Subject: **Revised Permit Modification Request for the Section 404 Individual Permit, Section 401 Individual Water Quality Certification and CAMA Major Development Permit** for the proposed improvements to US 70 from existing four lanes at Radio Island to north of Olga Road (SR 1426), Carteret County, State Project No. 8.1162501, Federal Aid Project STPNHF-70(43), TIP R-3307, Debit \$570 (NCDWR) and \$100 (NCDCM) from WBS 34528.1.1

Please see the enclosed revised permit drawings, impact summary sheet, and NCDMS acceptance letter for the above referenced project.

This revision serves to update the Permit Modification Request, dated June 1, 2016. The stream impact and surface water total at site 2 has been amended with the as-built total.

N.C.D.O.T.
 DIVISION OF HIGHWAYS
 CARTERET COUNTY
 PROJECT: 34528.1.1 (R-3307)
 US 70 FROM EXISTING FOUR LANES
 AT RADIO ISLAND TO US 70 NORTH
 OF SR 1429 (OLGA ROAD)

Permit Drawing
Sheet 5a of 34
Revised 26 Aug 2016

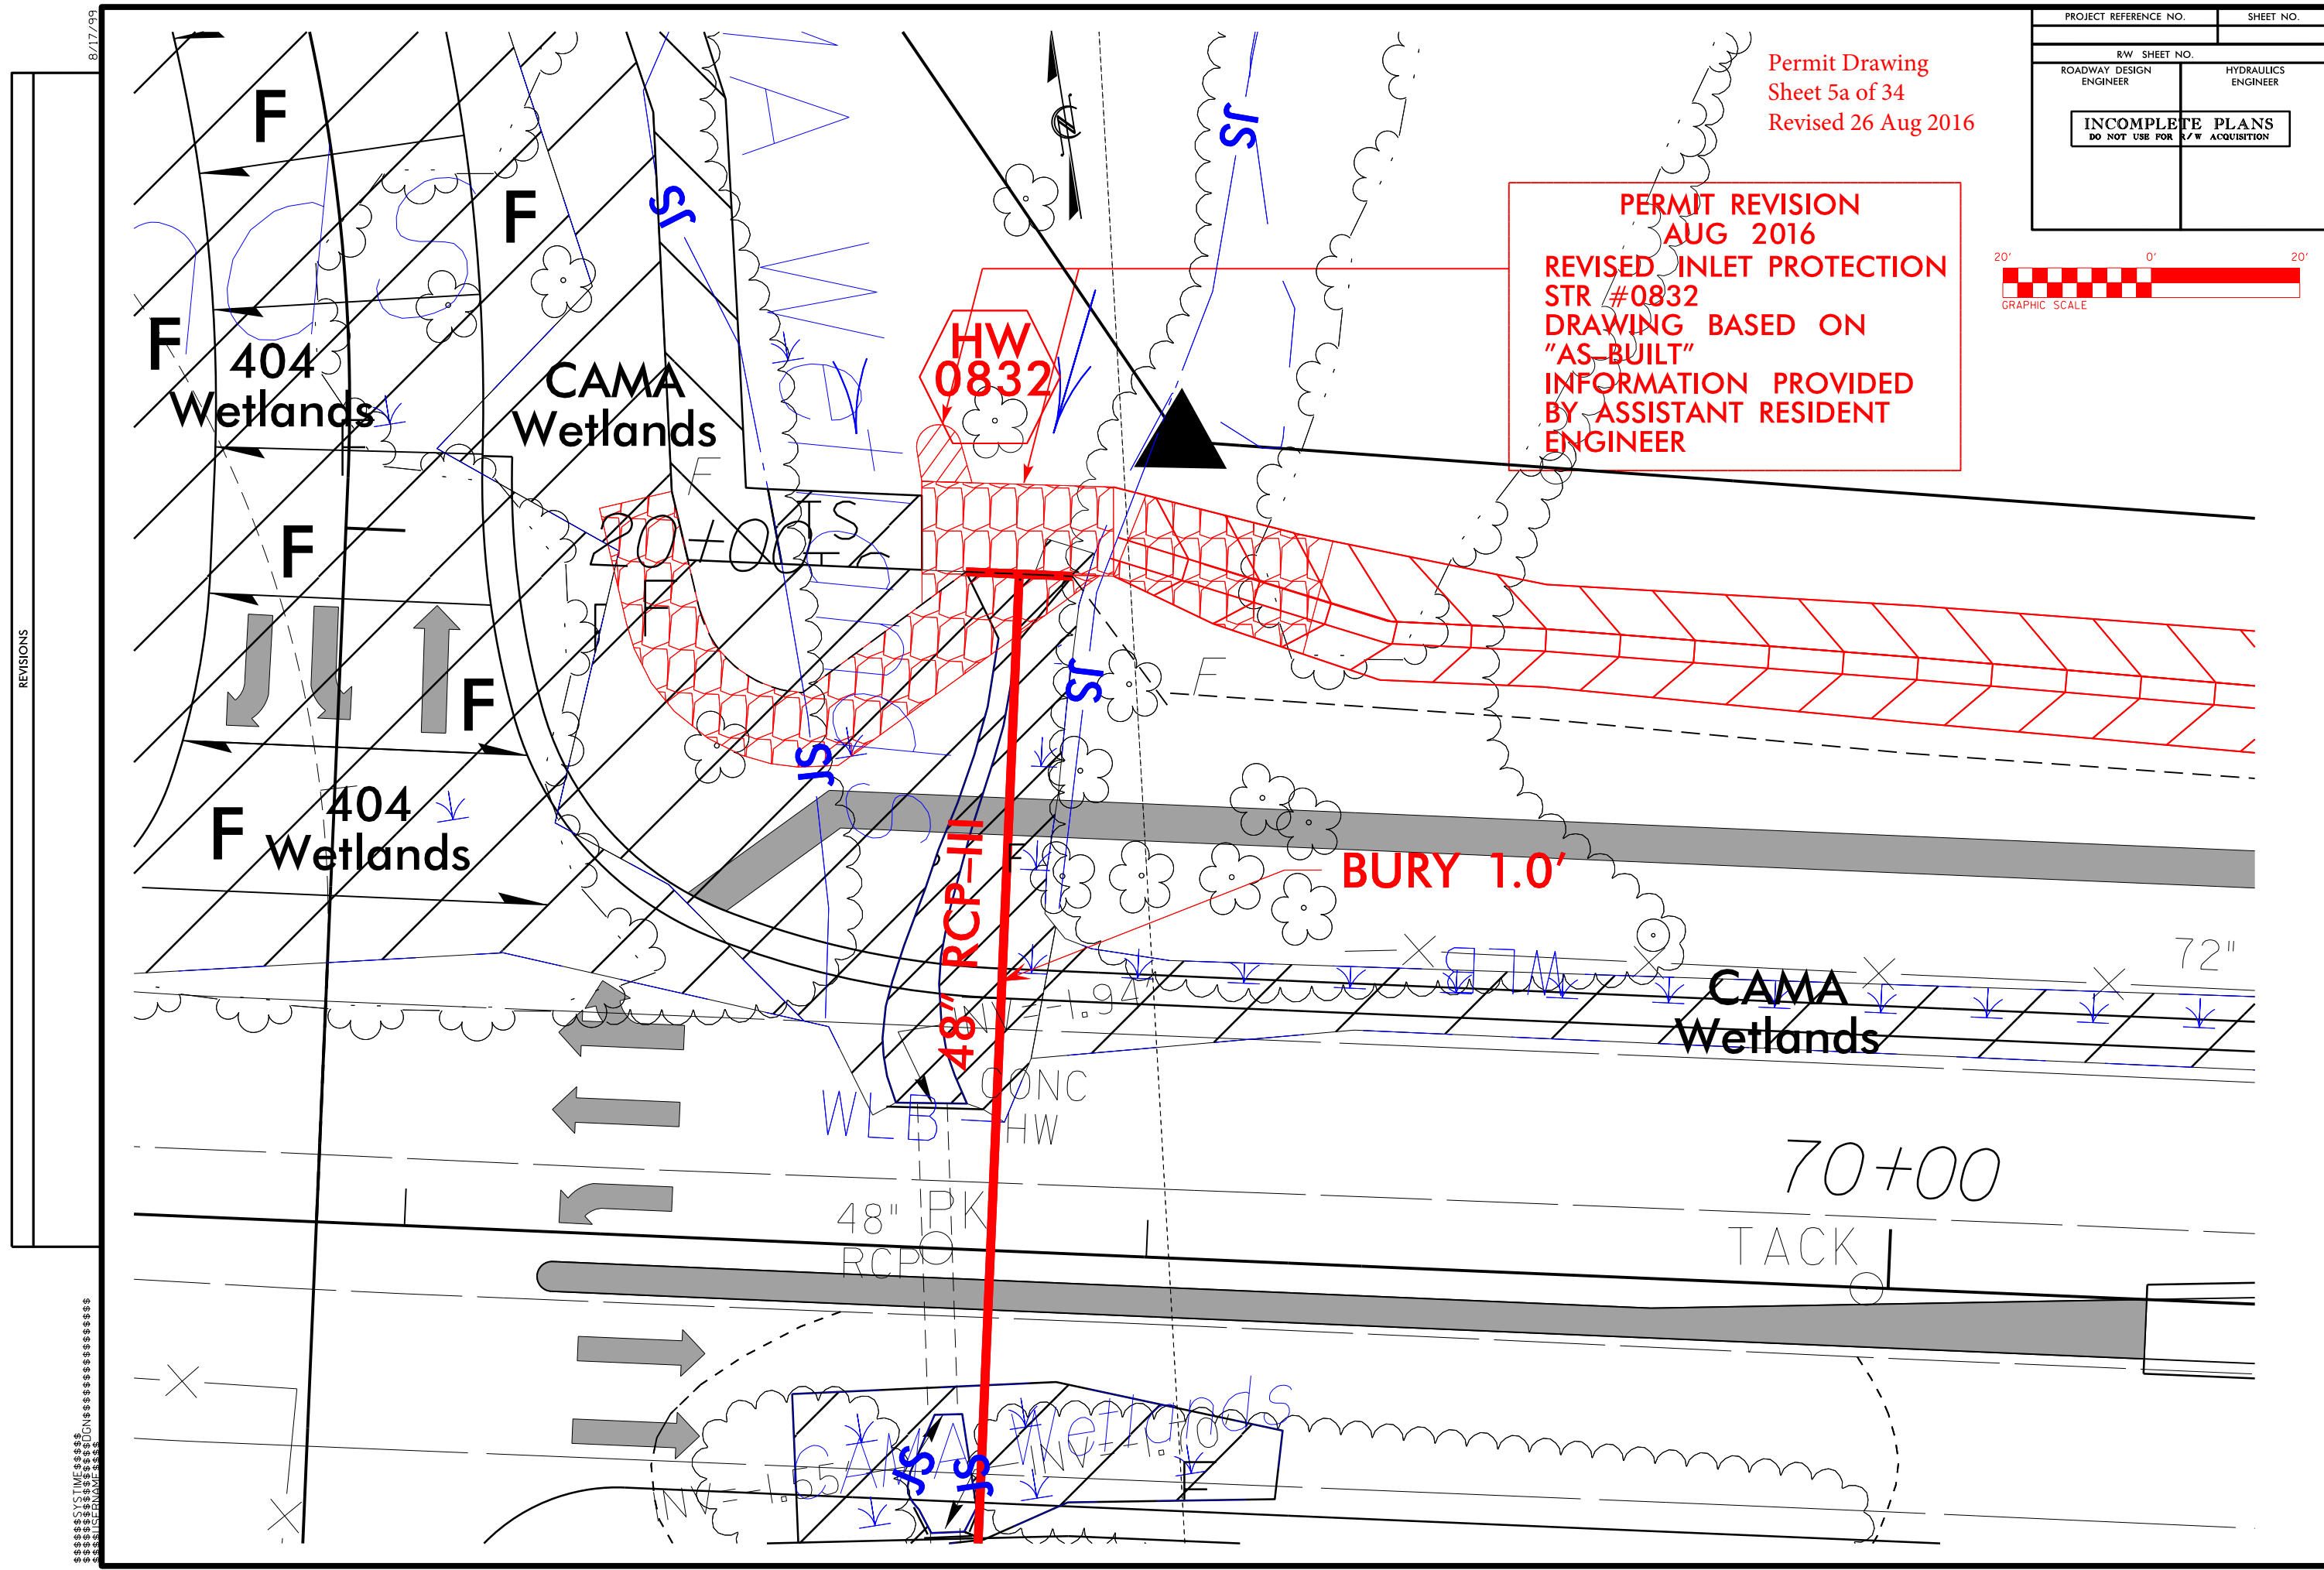
PERMIT REVISION
AUG 2016
REVISED INLET PROTECTION
STR #0832
DRAWING BASED ON
"AS-BUILT"
INFORMATION PROVIDED
BY ASSISTANT RESIDENT
ENGINEER

**Permit Drawing
Sheet 6 of 34
Revised 26 Aug 2016**

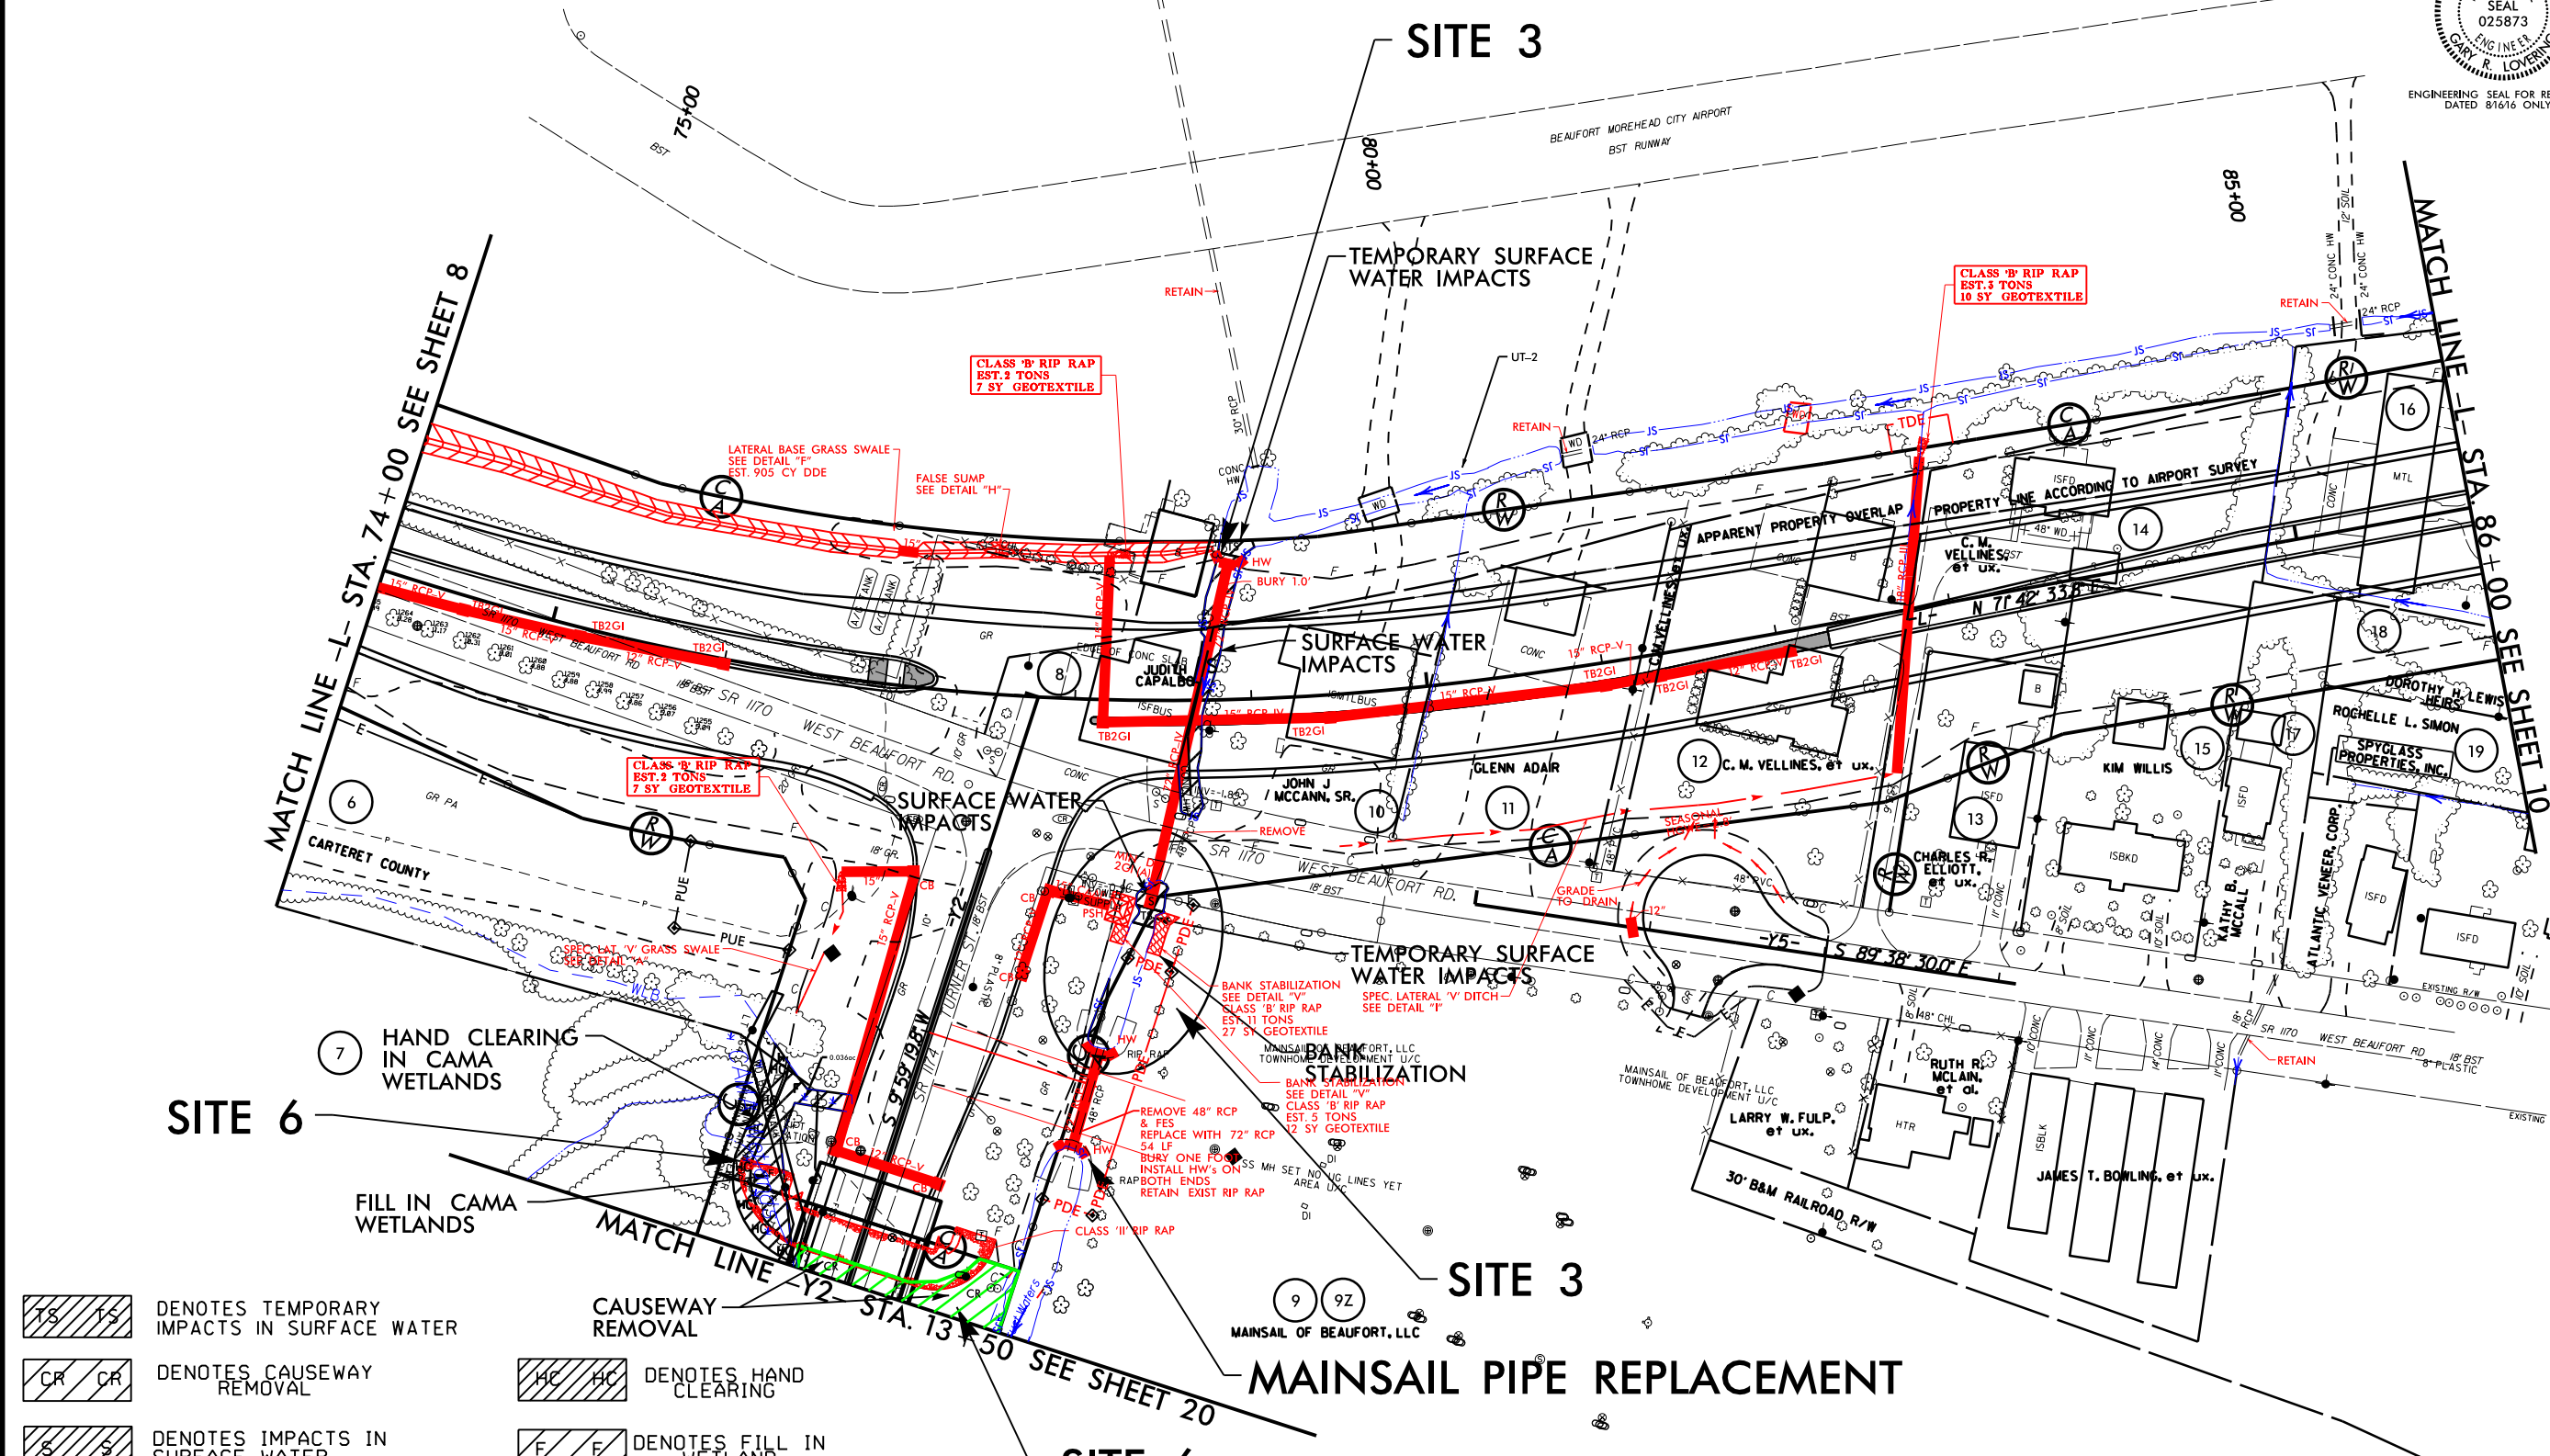
The 48" RCP and Flared End Sections installed by the developers of the MAINSAIL property are being removed and replaced by NCDOT. The replacement pipe will be a 72" pipe with headwalls on both ends. The pipe will be buried one foot and the existing rip rap will be maintained. There are no additional impacts to the stream.

MAINSAIL PIPE REPLACEMENT
